Access Compliance Report

Public Rights-of-Way

(Curb Ramps)

Intersection ID: 53017	Main Street: STEEL_HOUSE_BV	Cross Street: CHARTRES_LN	Location: NW
ADA ID: 69D5B7296104	Ramp Type: Directional1	Initial Pass/Fail: Pass	Overall Compliance: No
		Severity Score: 2.5

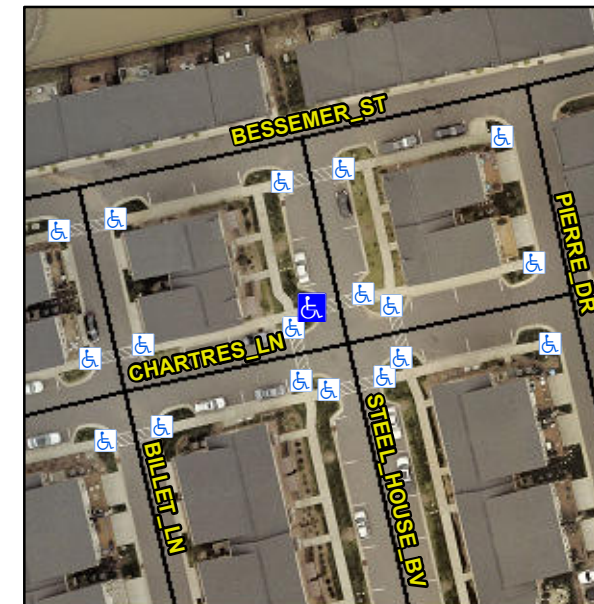
Remove & Replace Detectable Warning System. Remove & Replace Gutter.

R305.1.4, R304.5.3
